RHODE ISLAND ATOMIC ENERGY COMMISSION

DOCKET NO. 50-193

AMENDMENT TO FACILITY LICENSE

Amendment No. 21
License No. R-95

FIGURE 6.1

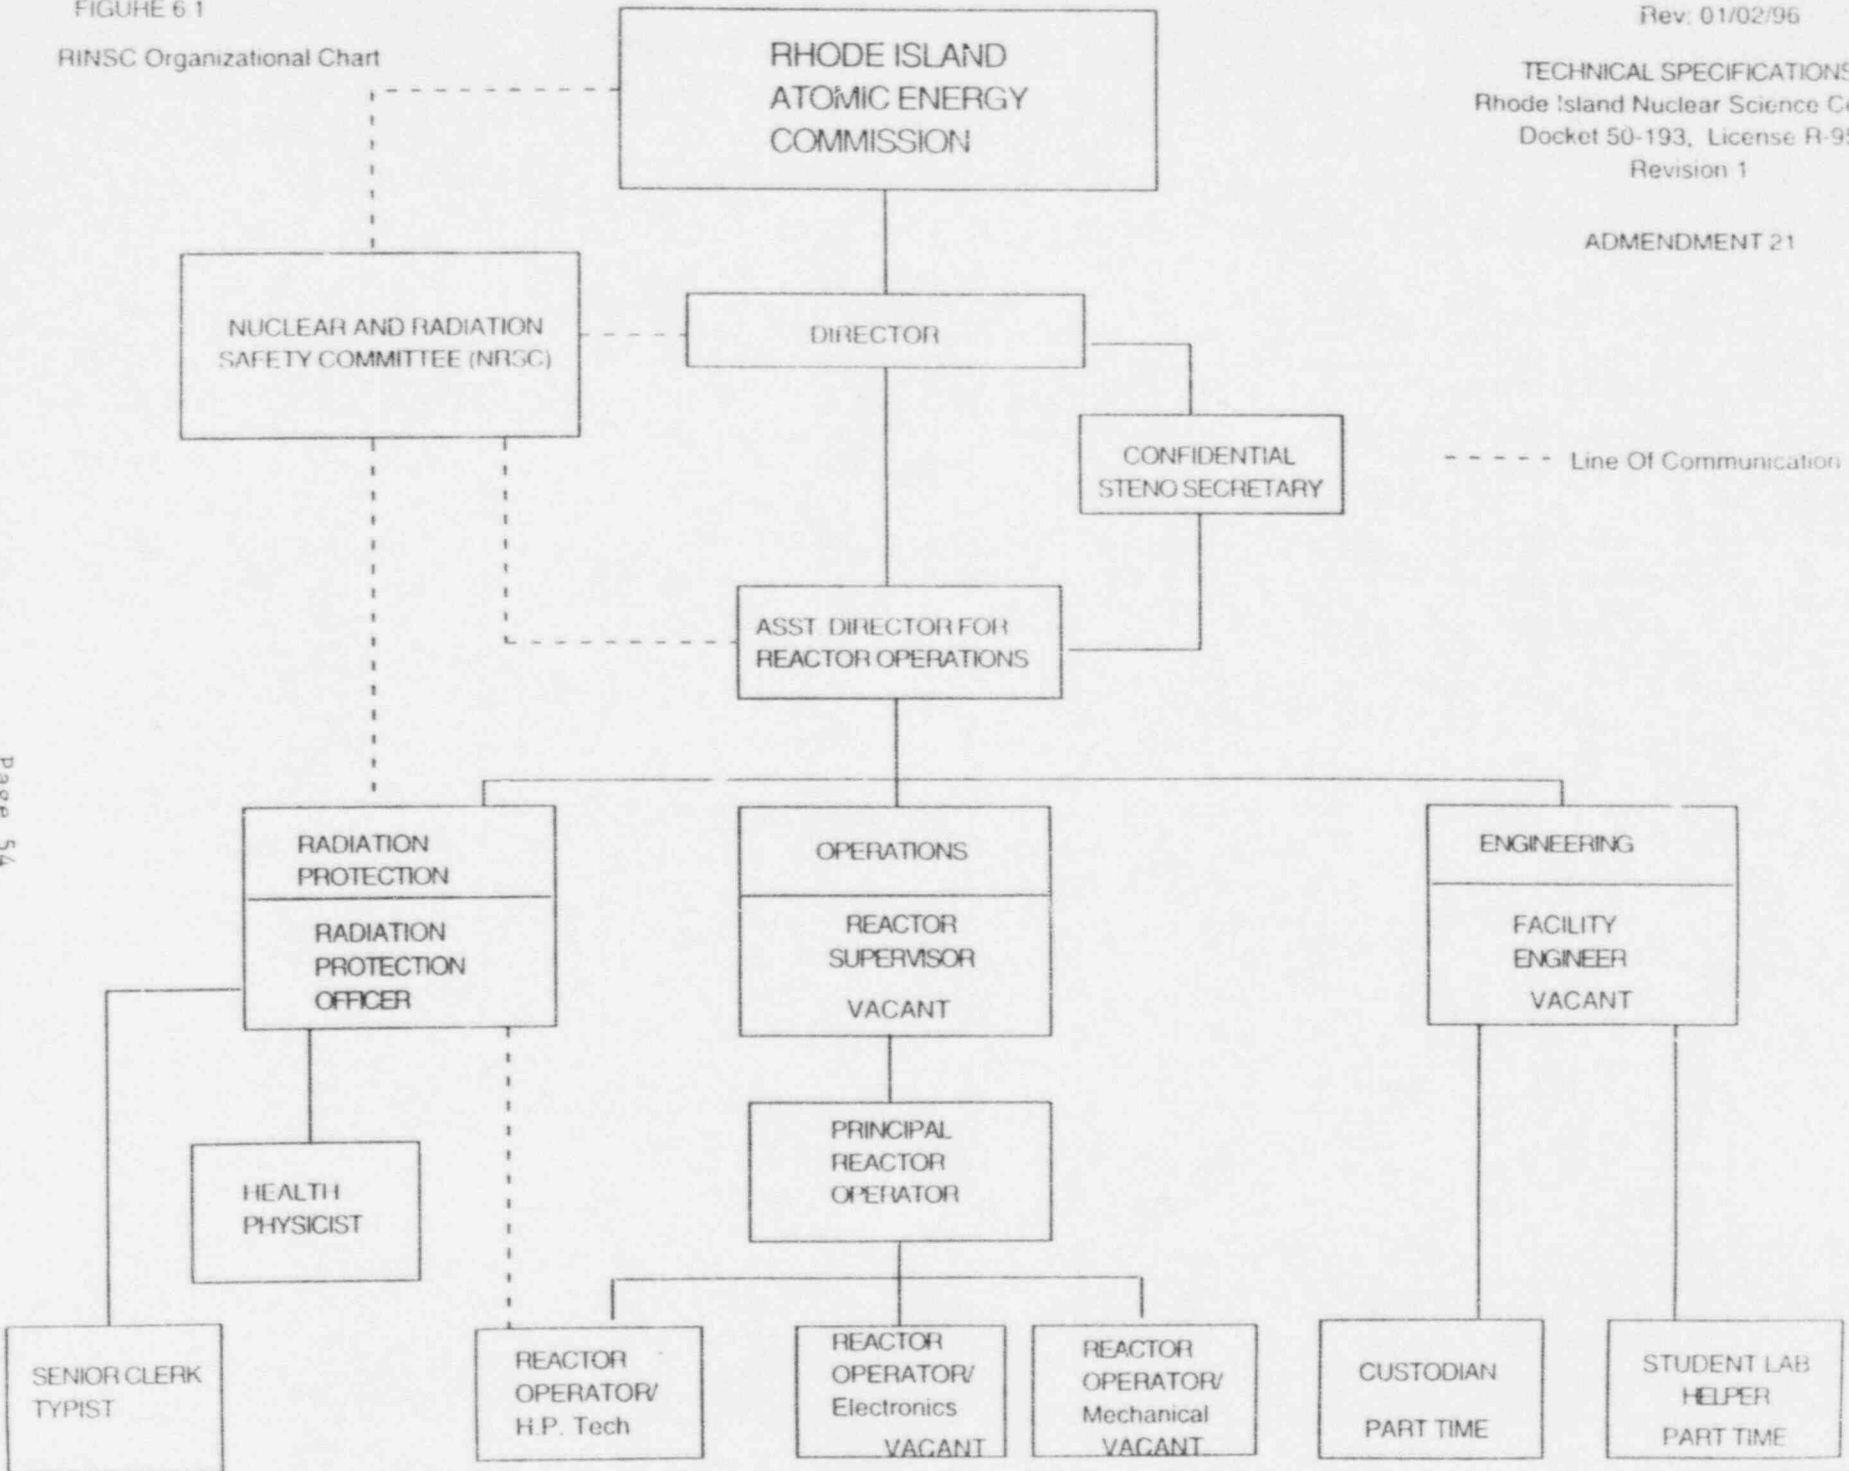
1. The Rhode Island Atomic Energy Commission (**RIAEC**) shall have the responsibility for the safe operation of the reactor. The organization of RIAEC is shown in Figure 6-1. The RIAEC shall appoint a Director and a Nuclear and Radiation Safety Committee (**NRSC**) consisting of a minimum of seven members, as follows:
